UNIVERSITY OF FLORIDA  
TRAINING REACTOR  
LICENSE NO. R-56  
DOCKET NO. 50-83

APPLICATION FOR CONVERSION FROM  
HIGH-ENRICHED TO LOW-ENRICHED  
URANIUM FUEL

Amendment 25  
UFTR Technical Specifications

UNIVERSITY OF FLORIDA TRAINING REACTOR  
FACILITY LICENSE: R-56, DOCKET NO. 50-83  
REQUEST FOR CHANGE IN TECHNICAL SPECIFICATIONS  
APPROVING HEU TO LEU CONVERSION

Figure 4-3 HEU Fuel Bundle XY Cut

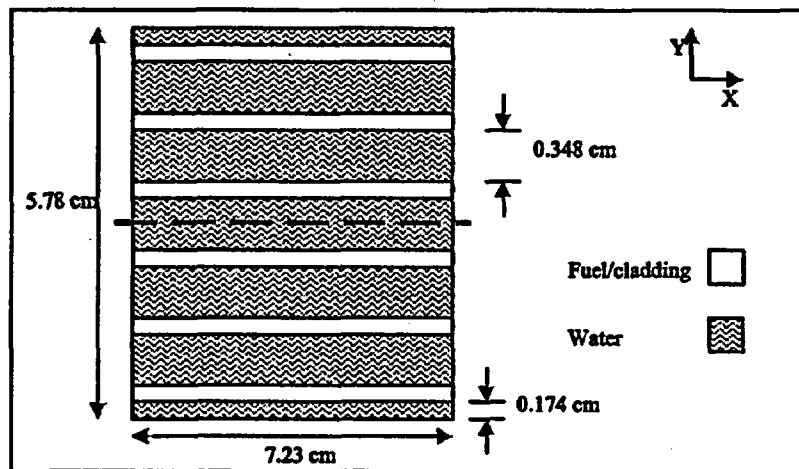
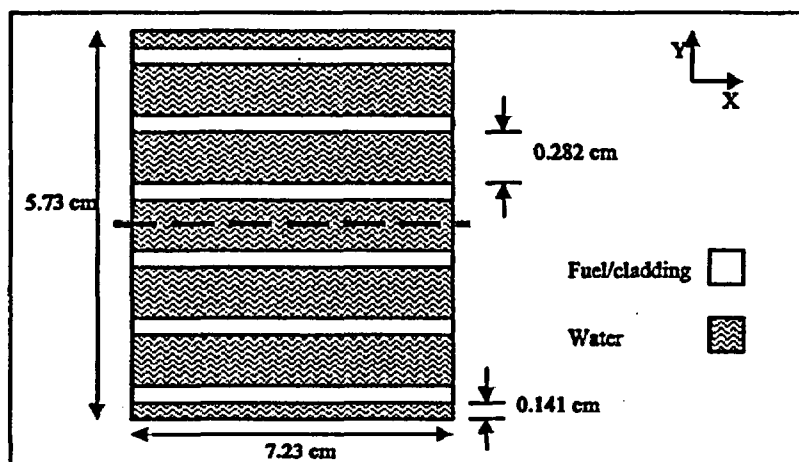
Fourth, on page 15 of the Tech Specs, in Section 3.7, Fuel and Fuel Handling, paragraph (1), the description of fuel elements is changed from "fuel elements consisting of 11 plates each . . ." to "fuel elements consisting of 14 plates each . . ." This change is necessitated by the basic LEU fuel assembly design selected for the conversion as described in Section 4 of *Attachment II* for the LEU fuel.

The LEU fuel bundles are composed of 14 fuel plates with a water gap of 0.282 cm. Figure 4-4 depicts the layout of the fuel plates and water gaps in a LEU fuel bundle.

- (1) The maximum fuel loading shall consist of 24 full fuel elements consisting of 14 plates each containing enriched uranium and clad with high purity aluminum.
